**PARADISE DAM**  
**FLOOD EVENT OF JANUARY TO MARCH 2013**  
**REVIEW OF DAM SAFETY MANAGEMENT**  
**ACTIONS**

**DRAFT REPORT FOR THE OFFICE OF WATER  
REGULATION**

**REPORT NO. DC 13127**

2<sup>ND</sup> AUGUST 2013

**Figure 6 – Rock and Gravel in the Near Vicinity of the Dissipator**

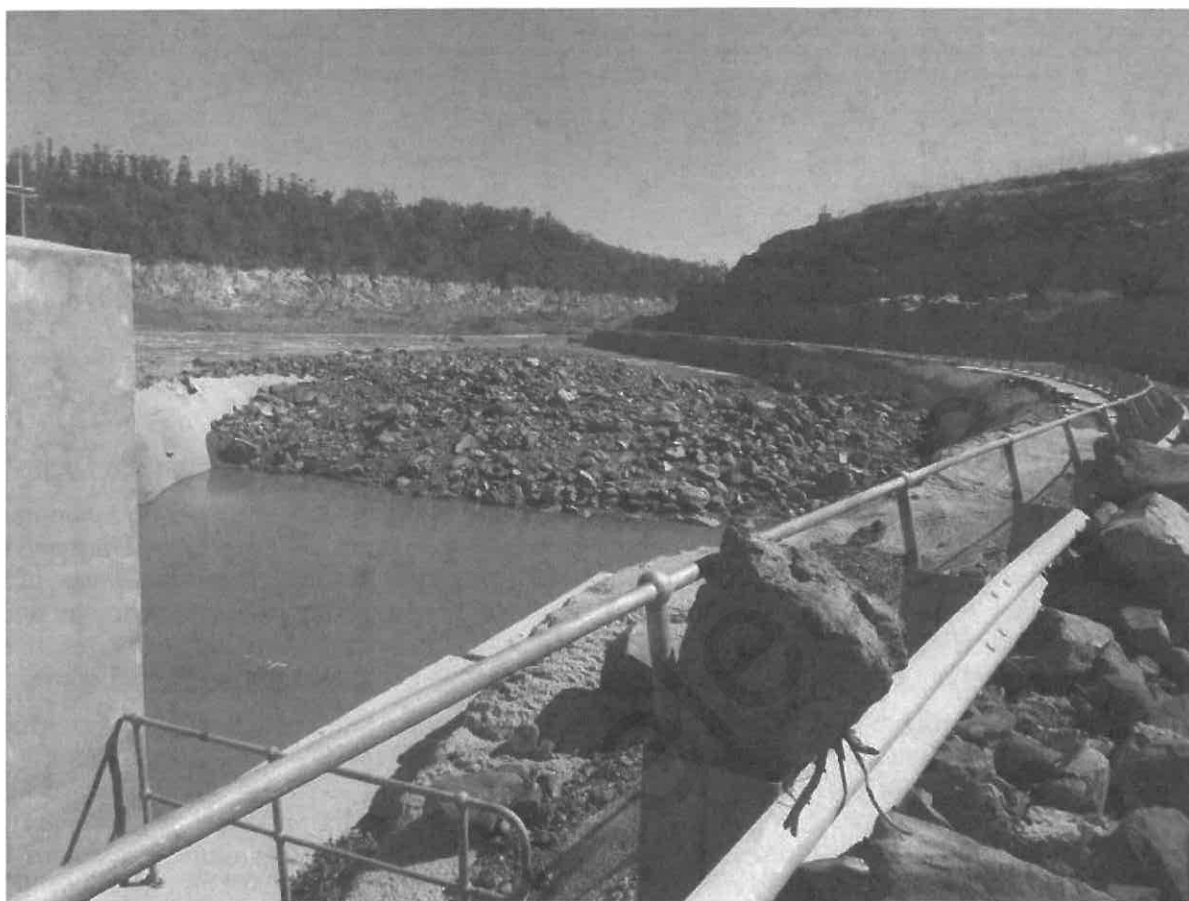
3. Observed behaviour of dissipation flows – a hydraulics specialist, Mr Eric Lesleighter, was engaged by SunWater to advise on the spillway performance during the 2010/2011 flood event. His report is Lesleighter (2012). The first issue to be noted from his advice is that the spillway flow is not two dimensional as would normally be expected in a long uncontrolled spillway. This is mainly attributed to the rise in the elevation of the dissipator apron toward the left end of the spillway. Eric Lesleighter believes that the recirculation pattern which has been set up is accentuated by the scour which occurred on the lower left abutment in the 2010/2011 flood event and that this recirculation is a mechanism for feeding rock and gravel back into the dissipator apron. Eric recommended that measures be taken to interrupt the recirculation flow. No such measures have yet been implemented. This relates to the potential abrasion problem mentioned under our preceding point.

The second point from Eric Lesleighter's advice is that the dissipator is acting more like a roller bucket than a hydraulic jump dissipator as was intended. This raises questions in our minds which would require specialist advice. There has been reliance by SunWater on high tailwater levels both in terms of cushioning the energy of the spillway flow and of the beneficial effects on dam stability. Mr Malcolm Barker of GHD alluded to the first of these issues in sentence 1, paragraph 1, sub-section 7.5 of his review of the comprehensive risk assessment (Barker 2009). As regards stability, in a true hydraulic jump spillway the river tailwater level would not be fully available to stabilize the dam. In the actual dissipation flows, whilst the tailwater is virtually against the overflow jet, there would be pressure fluctuations which may mean it is unwise to rely on the full tailwater depth as a stabilizing force. SunWater engineers are aware of these issues. Our aim is to emphasize the uncertainty of the tailwater effects.

Figure 7 – Progression of Scour at Kariba Dam

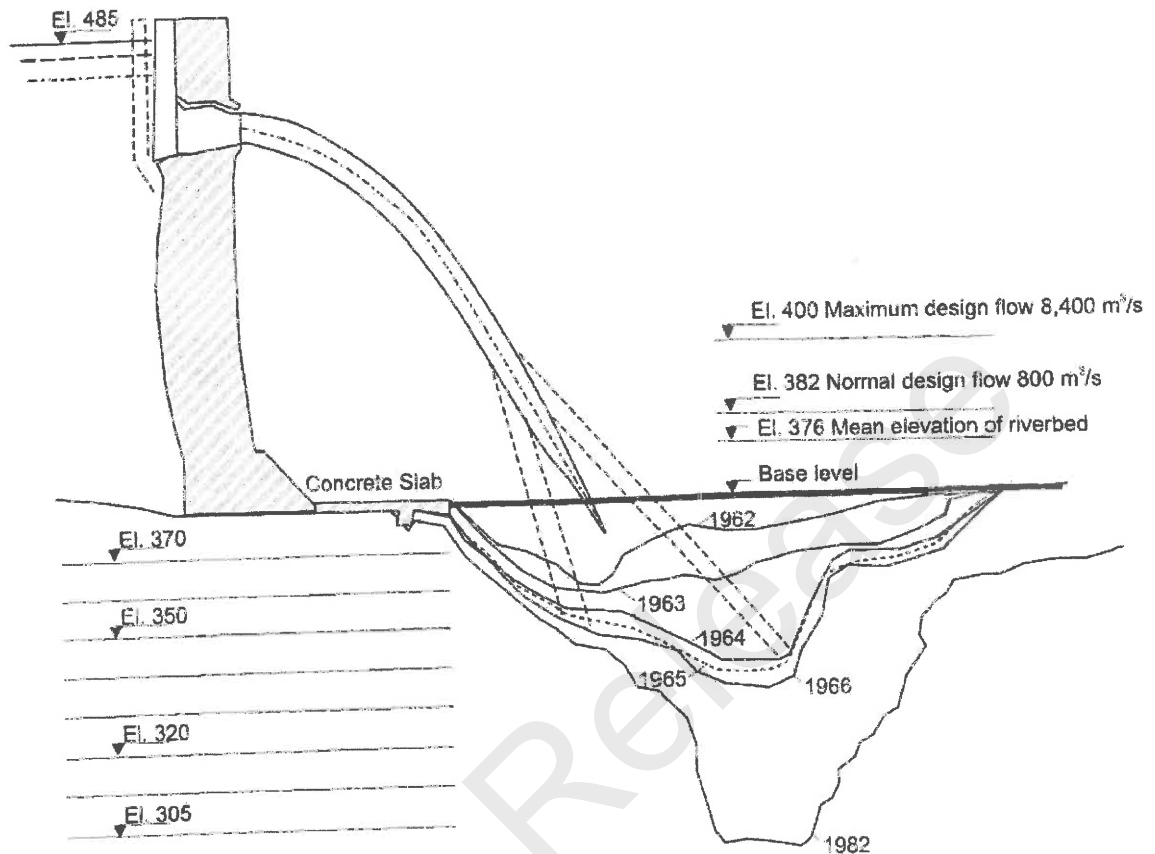
2. The rock in the energy dissipation zone is susceptible to deep scour – inspection after the flood revealed major rock scour. There are some points to be made about rock scour in the energy dissipation zones of dams. Firstly, experience shows that major rock scour in a large flood is not necessarily the end of the scour process. The classic demonstration of this reality is the case of Kariba Dam on the Zimbabwe/Zambia border (Bollaert 2005). In that case scour continued from successive floods over decades, eventually leading to a scour hole over 80m deep. **Figure 7** from CBDB (2002) shows the progression. Conditions at Paradise Dam are quite different but the possibility of further scour cannot be ruled out on the evidence available at this stage. Secondly, experience of scour at large dams is highly variable for reasons which are not immediately obvious. Because of large flows in its rivers, Brazil offers instructive lessons on rock scour at dams (CBDB 2002). Foz do Areia and Salto Santiago dams on the Iguacu River and Machadinho and Ita Dams on the Uruguay River are all within the one geologic province of more or less horizontal basalt flows. All four dams have experienced large floods with comparable peak discharges in the order of 10,000m<sup>3</sup>/s to 19,000m<sup>3</sup>/s and comparable energy dissipation heads in the range of 90m to 130m. Yet Ita and Machadinho Dams experienced major rock scour with up to 200,000m<sup>3</sup> of fresh rock being removed whilst the experience at Salto Santiago and Foz do Areia Dams was negligible rock scour. When these dams are examined in more detail it becomes clear that engineering judgment is a poor guide to the likelihood of rock scour and that account needs to be taken of detail metrics of unit power, stress relief factors, rock joint spacing, orientation and cementation among other factors. This reality points to the need to apply rock scour estimation methodologies such as those developed by Annandale and separately by Bollaert as an aid to judgment.

**Figure 9 – Probability of Failure versus a Safety Factor**

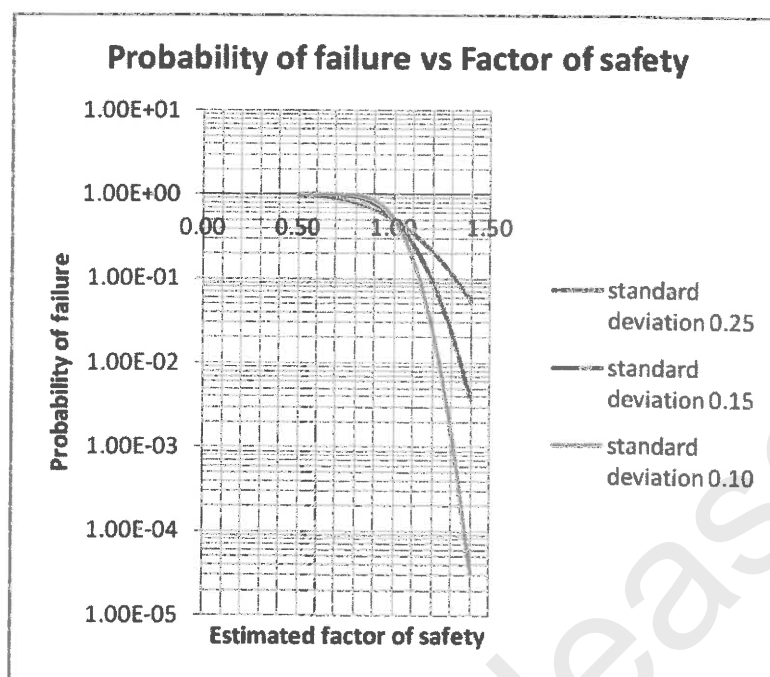
The unknown is  $\sigma_F$  the standard deviation of the *probability density function* of F. That value is difficult to estimate but has been estimated by Monte Carlo simulation.

Analysts should not rely on **Figure 9** but should consult authoritative texts on *reliability analysis* and make their own assessments. A brief treatment of the concept can be found at pages 339 to 342 of Hartford and Baecher (2004).

**Figure 10 – End Sills Destroyed at Left End of Dissipator**

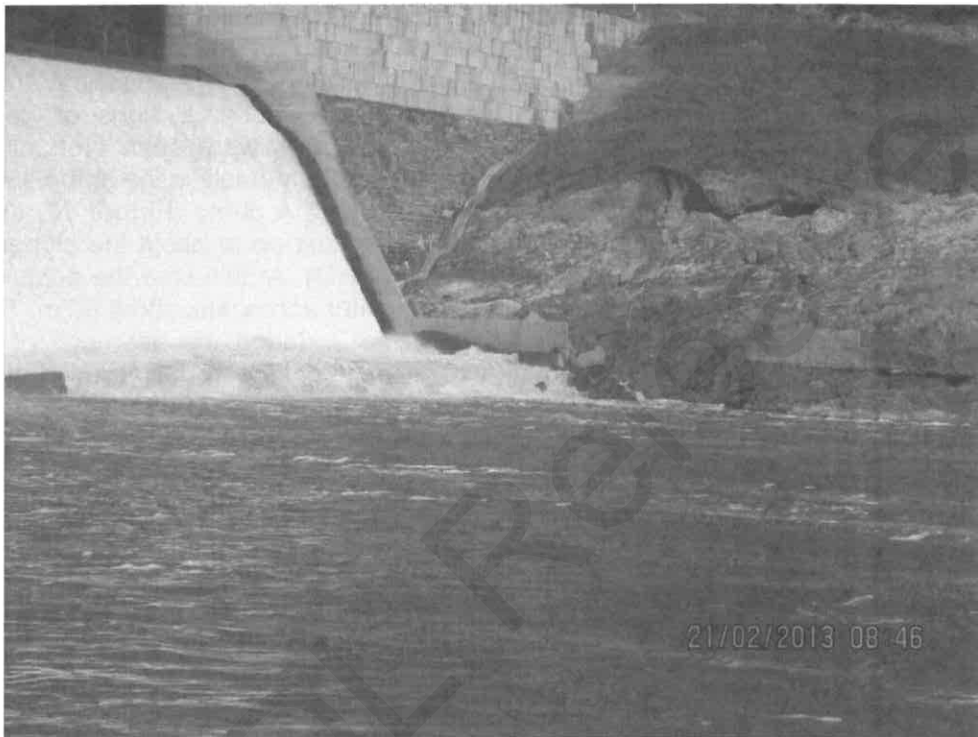
There were 46 days from the first observation of dissipator damage to the commencement of remediation work. But 26 of those days were lost to a second flood, leaving 20 days for actual work on site. Whilst engineers could make plans in that lost time, they did not have an accurate picture of the damage for which they needed to plan. Knowledge of the true nature of the damage and scour emerged progressively, mainly up to early April but even beyond. For example, the weekly progress report of 26 April advised of a new scour hole found at Monolith J. Before remediation could commence,

considerable work was needed to remove rock and gravel from the release channel, to get the environmental flow gate functional, to build a cofferdam around the area downstream of the dissipator, to build a culvert over the release channel, to dewater the area of the scour holes, to take care of lung fish and so on. A detailed examination of the bar chart program demonstrates that it was not reasonably practicable to commence remediation earlier. Throwing more resources at the task would not have achieved an earlier result because of problems such as unfamiliarity with the dam for planners and space limitations on the ground.

The methods for determining the damage were reasonable. Consideration was given to reaching the left end of the dissipator from the northern bank of the river but that route appears to have presented difficulties – slipperiness after rain, permission needed and so on. The inescapable fact is that determination of damage could not be done properly until the site was dewatered and that required a cofferdam. The most reliable, and therefore the fastest access was from the right bank. A culvert at the release channel and access roads had to be constructed. Given the time available for planning, the engineers produced as good a plan as could reasonably be achieved.
